PLAN VIEW – EXPANSION JOINT

PROJECT — BRIDGE NO. 68 SOUTH BURLINGTON U.S. 2 OVER I-89
STATE PROJECT — IM DECK (36)
FEDERAL PROJECT —
CUSTOMER — J A McDONALD
LOCATION — CHITTENDEN COUNTY, VERMONT
DESCRIPTION — EXPANSION JOINT DETAILS EASTBOUND AT PIER 2

SHEET NO. 4 OF 8

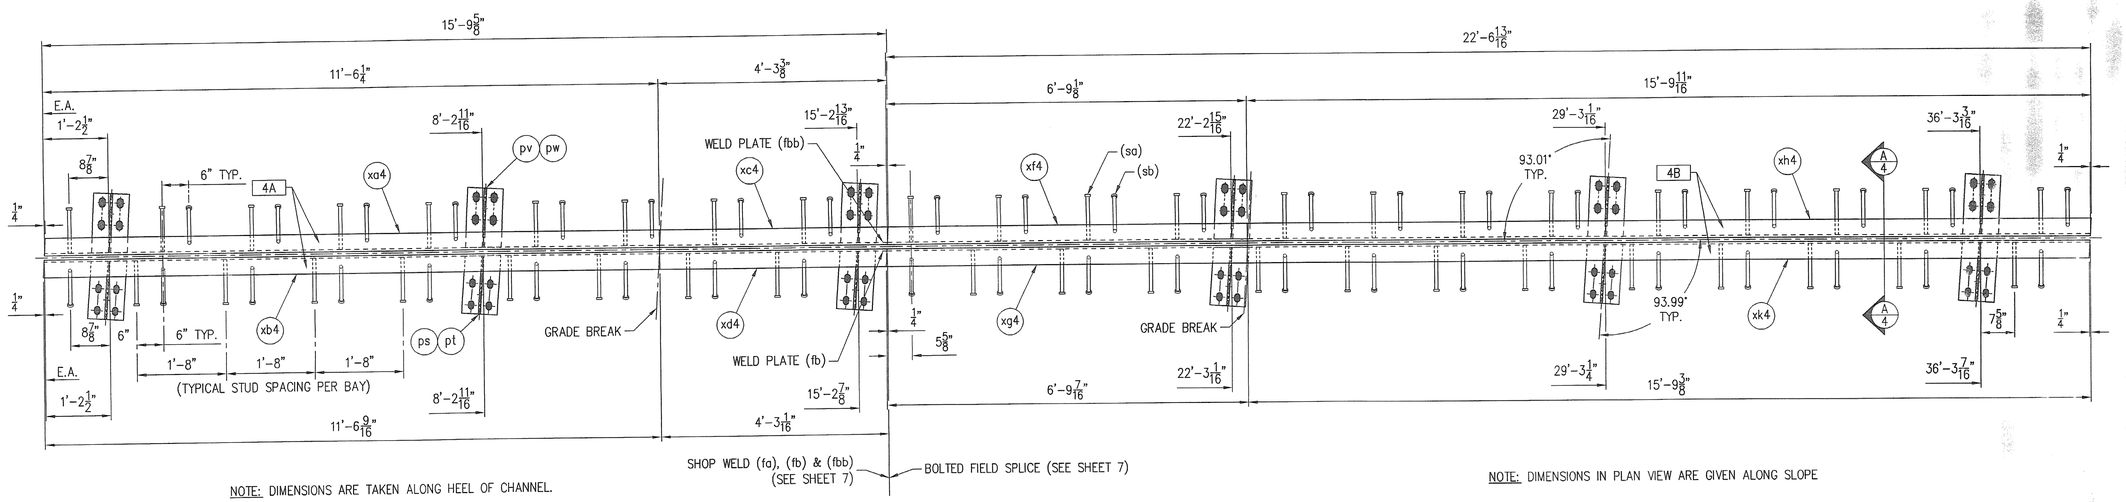
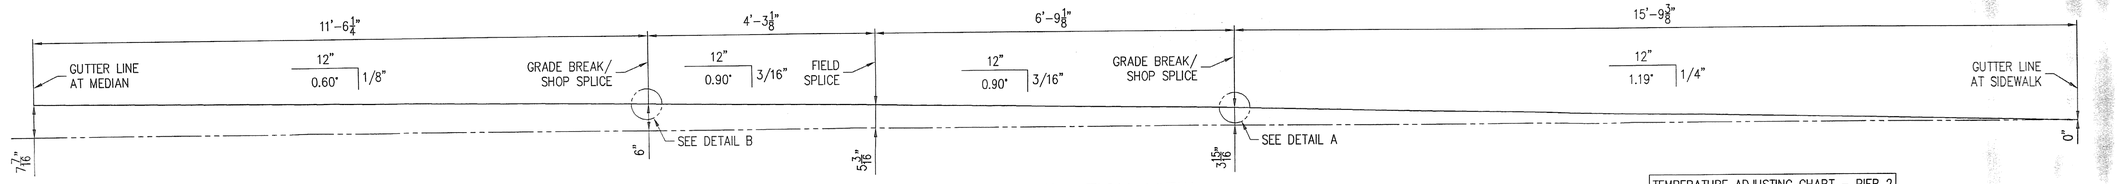
APPROVER NOTE:
STOOL LENGTHS HAVE BEEN REVISED PER CONTRACTORS FIELD MEASUREMENTS TAKEN JANUARY 19, 2001.
